Golden Heights - Webster

DRAWING TITLE
 EXISTING CONDITIONS & PROPOSED PARKING PLANS

JOB NUMBER 1421
 JOB TITLE
 WEBSTER HOUSING AUTHORITY
 PROPOSED PARKING EXPANSION

RE: Golden Heights - Proposed Parking

PROPOSED PARKING PLAN
 SCALE: 1"=20'

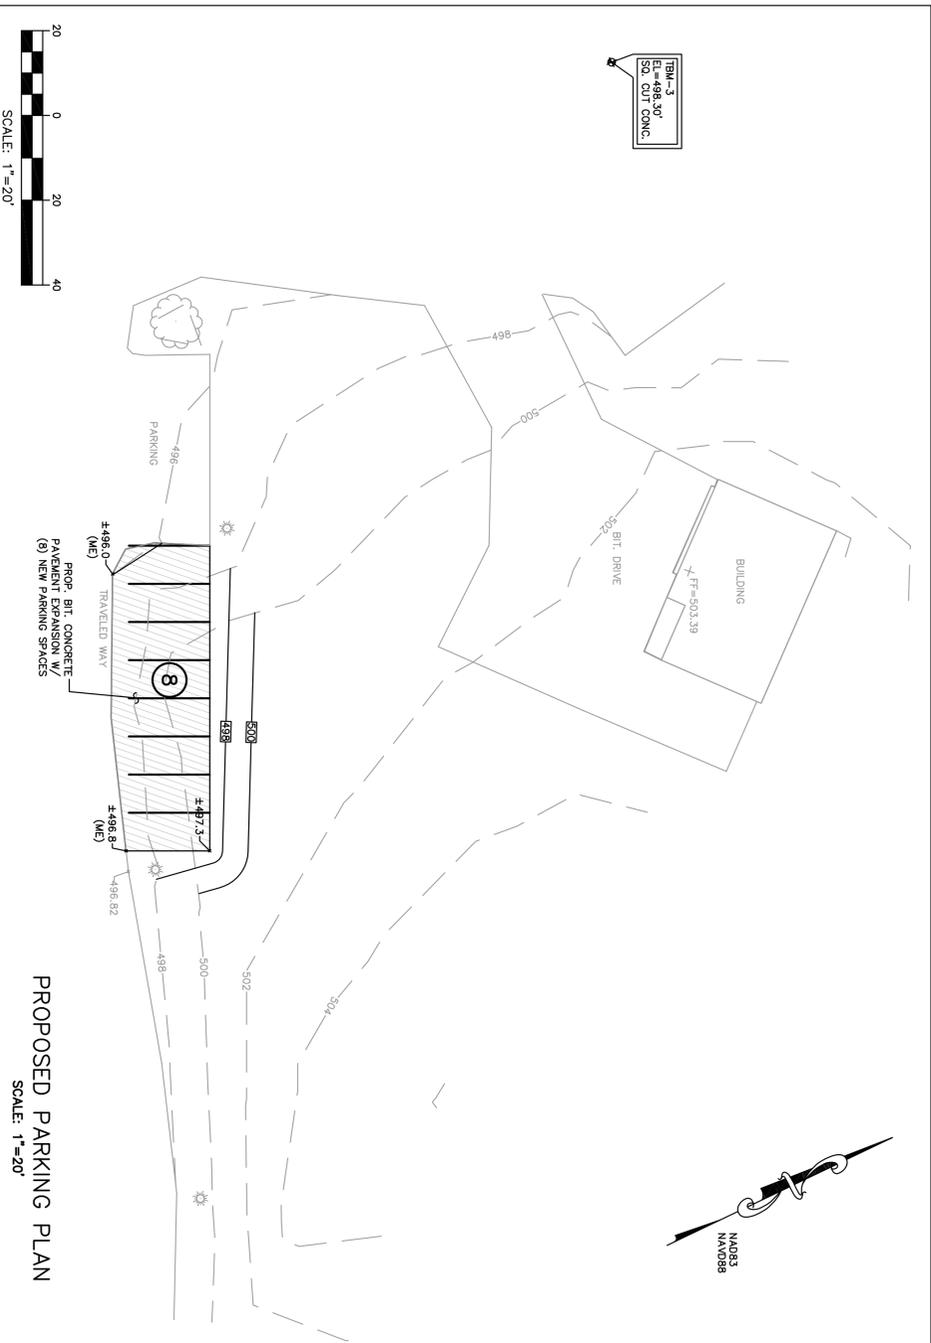
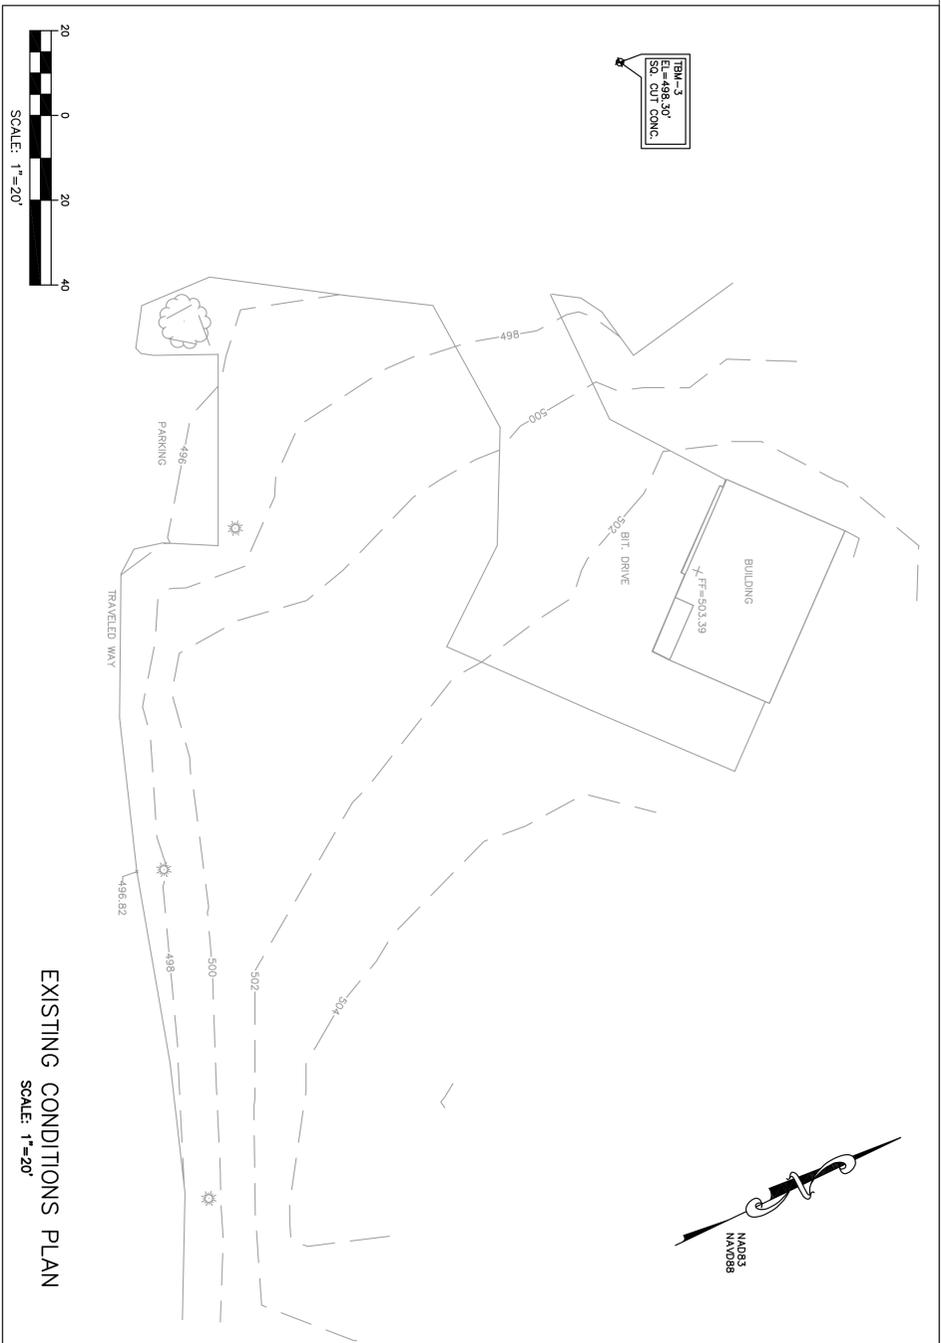
It appears they addressed the HC spaces as long as they are not within the new parking areas as they don't have HC access to the buildings.

The drainage is about as good as it gets assuming it is working properly.
It appears from the plan that stormwater from the No. 1 proposed parking area is retained on site and infiltrated.

Although Karl says the drainage system seems to be installed per plan, I would want to see if the system is working properly.

We also discussed they would need to add E&S controls.

1. The Golden Heights 1 development contains 46 total spaces of which 10 are designated as accessible spaces. Golden Heights 2, where the proposed parking is located, is proposed to contain 78 spaces (70 existing and 8 new) of which 6 are designated as accessible. Based on 521 CMR 23.2.1, the number of accessible parking spaces is adequate. Parking counts have been provided by WHA.

2. The Site Utility Plan, showing the drain system, from the original construction drawings is attached. Based on my observations, the drain system appears to have been constructed in accordance with that plan. I've highlighted where the new parking is proposed.
